SPECTRA LOGIC

Spectra[®] 10K Library Firmware History

Spectra 10K Library Firmware History

Figure 1 Drive switch configuration screen.

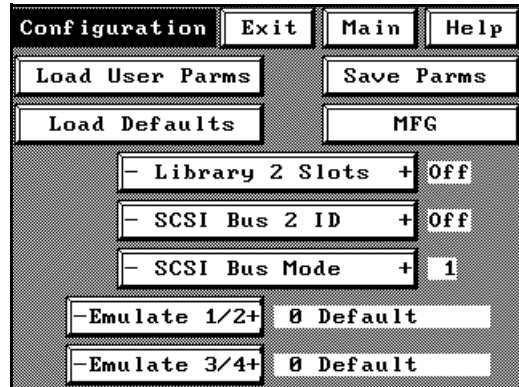
- Corrects front panel move problem.
- Removes load/unload retries and device resets (post drive error on front panel).
- Changes move to drive to wait 60 seconds for drive ready.
- Adds support for AIT-2 inquiry strings.
- Improves menu interface performance for fibre controller.
- Adds switch option 4 to set SDX-300C inquiry string (no switch update).
- Changes copyright to 1999.
- Changes SCSI_size to channel specific.
- Changes EXB-120 emulation to EXB-210.
- No longer hangs if SCSI bus not stable at power-up.
- Now must ship with SCSI bus mode set to 1 (as shown in Figure 1).

Figure 2 Drive switch configuration screen.

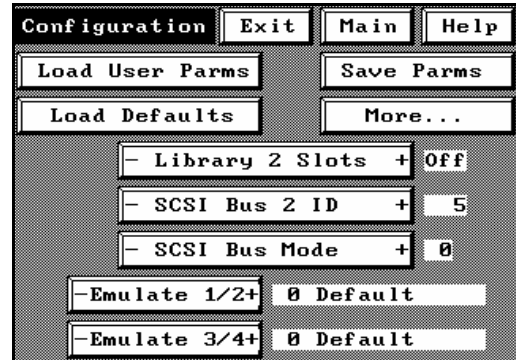
- Adds support for split logical libraries via second serial SCSI ports (the drive switch configuration screen selection has been separated for Drives 1/2 and 3/4), as shown in Figure 2.
